RE: Approved Determination of the Revised Groundwater Sustainability Plan Submitted for the San Joaquin Valley – Merced Subbasin

**STATEMENT OF FINDINGS REGARDING THE
APPROVAL OF THE
SAN JOAQUIN VALLEY – MERCED SUBBASIN
GROUNDWATER SUSTAINABILITY PLAN**

Exhibit A: Groundwater Sustainability Plan Assessment Staff Report – San Joaquin Valley – Merced Subbasin (August 4, 2023)

Groundwater Basin Name: Merced Subbasin (No. 5-022.04)
Submitting Agencies: Merced Irrigation-Urban Groundwater Sustainability Agency, Merced Subbasin Groundwater Sustainability Agency, and Turner Island Water District Groundwater Sustainability Agency #1
Submittal Type: Revised Plan in response to Incomplete Determination
Submittal Date: July 26, 2022
Recommendation: Approve
Date: August 4, 2023

Figure 2: Subsidence Monitoring Network¹⁴⁹

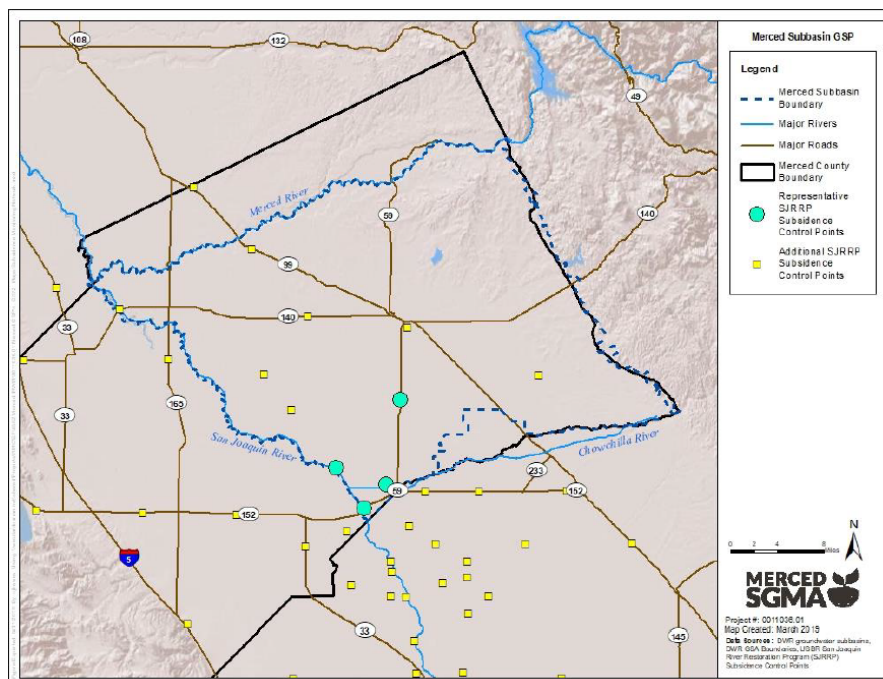
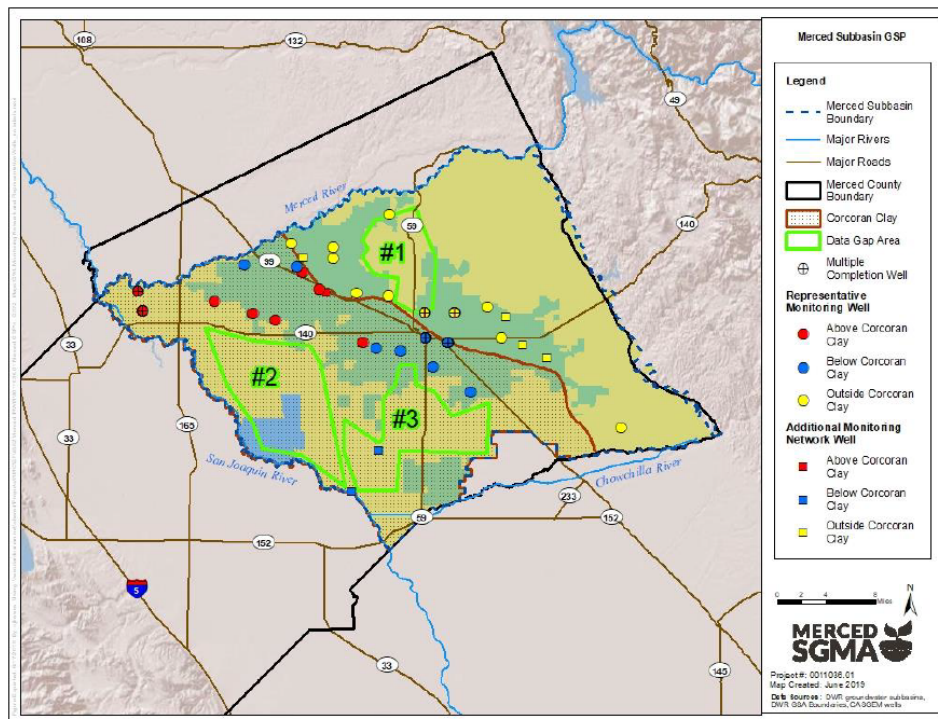
groundwater levels and the subsidence monitoring network, Department staff are concerned the GSAs will not be able to monitor subsidence adequately. Figure 2 shows the representative sites used by the Agencies to monitor for subsidence within the Subbasin. Figure 3 shows the water levels monitoring network and the data gap areas, including the wells which are monitoring Above Corcoran Clay layer and Below Corcoran Clay layer. The GSP states that there is a data gap along the western edge of the Subbasin and that installing wells along this area would help improve the understanding of subsurface groundwater flow between adjacent subbasins, depletions of interconnected surface waters, subsidence, and connection between principal aquifers. The GSP also states that there are plans to add wells for the Above and Below Corcoran Principal Aquifers in the southwesterly portion of the Subbasin and wells in the northwestern portion of the Subbasin.¹⁴⁸ While the GSP states data gap areas #2 and #3 and a plan to fill these data gaps will be submitted within two years of Plan approval, Department staff believe efforts on filling these data gaps are crucial for the Subbasin’s management of subsidence with the presence of the Corcoran Clay and the GSAs’ intentions to operate the basin below historical lows. It’s unclear to Department staff how the implementation of the Above Corcoran Sustainable Management Criteria Adjustment Consideration Management Action will be able to accomplish its goal given the data gaps. Department staff recommend the GSAs prioritize filling these data gaps and describing how filling these data gaps will assist in the successful implementation of the Above Corcoran Sustainable Management Criteria Adjustment Consideration Management Action. (See [Recommended Corrective Action 8](#))
